Access Compliance Report Public Rights-of-Way (Curb Ramps)

Main Street: IRVINE_AVE Cross Street: MESA_DR Location: NW

ADA ID: RPRK211015140839 Ramp Type: Type 1 - Perpendicular Diagonal Initial Pass/Fail: Pass Overall Compliance: No Severity Score: 4

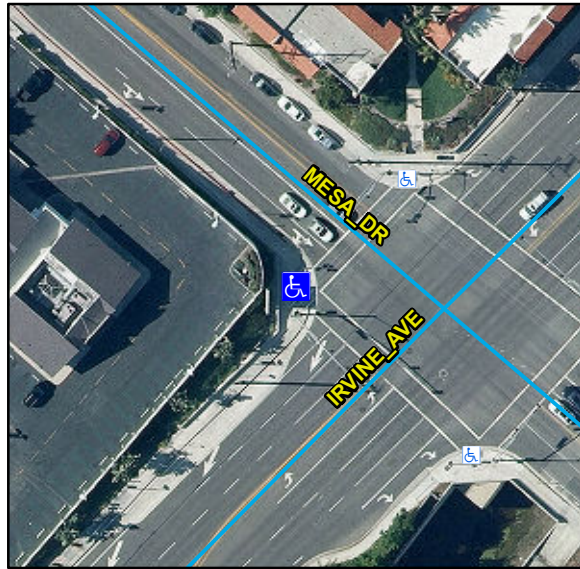
Compliance	Description	Data	Compliance	Description	Data
N/A	Ramp Length (in)	120	N/A	Flare Type LT	
Yes	Ramp Width (in)	48			Sloped
Yes	Ramp Run Slope (%)	6.2	Yes	Flare Slope LT (%)	5
Yes	Ramp Cross Slope (%)	1.3	N/A	Flare Traversable LT	Yes
N/A	Landing Present	Yes	N/A	Flare Type RT	
N/A	Landing Length (in)	60			Sloped
No	Landing Width (in)	47	Yes	Flare Slope RT (%)	7.9
Yes	Landing Run Slope (%)	1	N/A	Flare Traversable RT	Yes
No	Landing Cross Slope (%)	2.9	Yes	DWS Provided	Yes
N/A	Landing Movement Obstructed?	Yes	Yes	DWS Contrast	Yes
	Landing Movement Type	Wall	Yes	DWS Length (in)	36
N/A	Landing Shared	No	Yes	DWS Full Width	Yes
N/A	Clear Space	Yes	Yes	DWS Offset Left (in)	0
N/A	Clear Space To Crosswalk (in)	48	Yes	DWS Offset Right (in)	N/A
N/A	Marked Crosswalk 1	No	N/A	Marked Crosswalk 2	No
	Crossing 1 Direction	S		Crossing 2 Direction	E
	Marked Crosswalk 1 Width (in)	N/A		Marked Crosswalk 2 Width (in)	N/A

N/A	Ramp Inside Crosswalk 1	N/A	Yes	Ramp Inside Crosswalk 2	N/A
	Crossing 1 Slope (%)	4.2		Crossing 2 Slope (%)	4.2
	Crossing 1 Cross Slope (%)	2.6		Crossing 2 Cross Slope (%)	2.6
Yes	Gutter Ponding	No	No	Curb Slope	11
Yes	Gutter Lip Height (in)	0		Road Run Slope (%)	1.9
Yes	Gutter Run Slope (%)	1.4		Road Cross Slope (%)	3.3
No	Gutter Cross Slope (%)	4.2			
Yes	Overall Surface Condition: Acceptable		Yes	Perp Joint Present	Yes
	Cross Gutter Present?	No		Spandrel Present?	No
	Replace Cross Gutter?	N/A		Replace Spandrel?	N/A

Remove & Replace Curb Ramp With Two New Directional Ramps or Equivalent. Remove & Replace Gutter.
